NOTICE OF DECISION

**URBAN GROWTH PRELIMINARY DECLARATION / CLASS 3 SITE PLAN
REVIEW / CLASS 2 ADJUSTMENT / CLASS 1 ADJUSTMENT / CLASS 2
DRIVEWAY APPROACH PERMIT / CLASS 1 DESIGN REVIEW / PROPERTY
LINE ADJUSTMENT CASE NO.: UGA-SPR-ADJ-DAP-DR-PLA24-03**

APPLICATION NO.: 23-121805-PLN

NOTICE OF DECISION DATE: February 29, 2024

PRELIMINARY SITE PLAN - SOUTH
NORTHPLACE APARTMENTS PHASE 2
I&E CONSTRUCTION, INC.
SALEM, OREGON

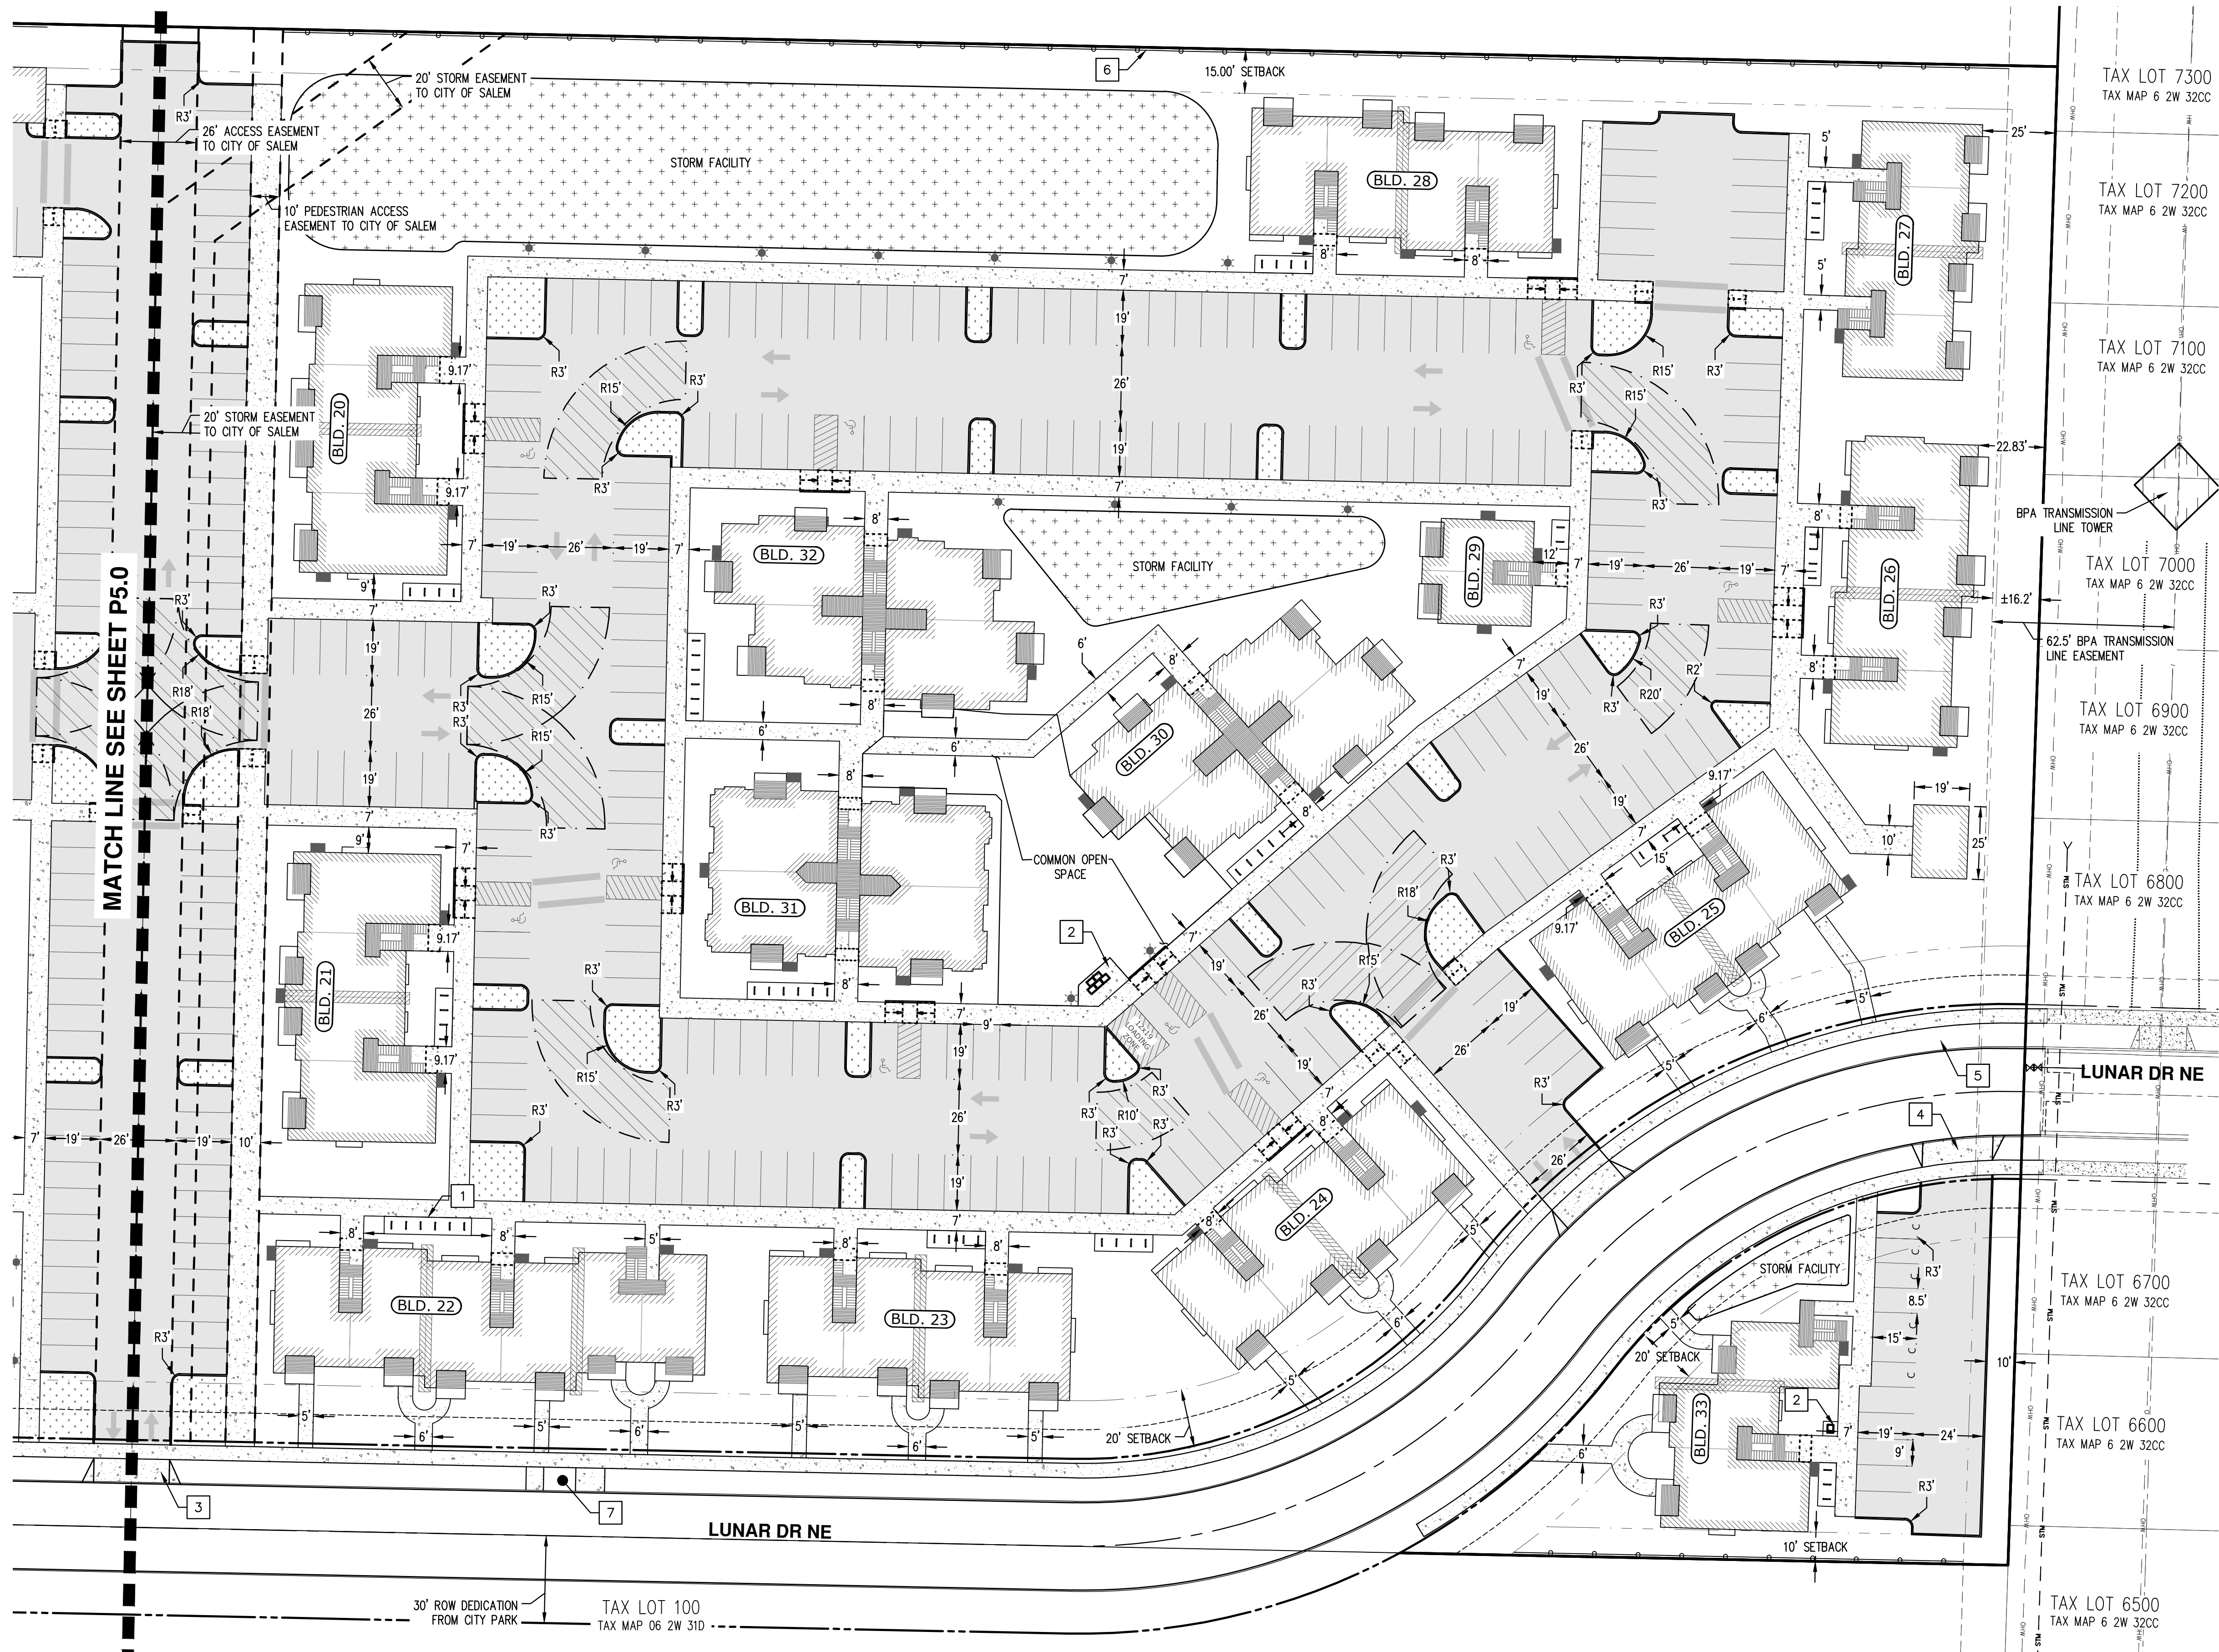
One of the transit stops shall be located on the east side of Lunar Drive at Building 5, approximately 50 feet north of the driveway as depicted in preliminary site plan drawing P5.0. The other transit stop shall be located at Building 22 as depicted in drawing P5.1 Note 7.
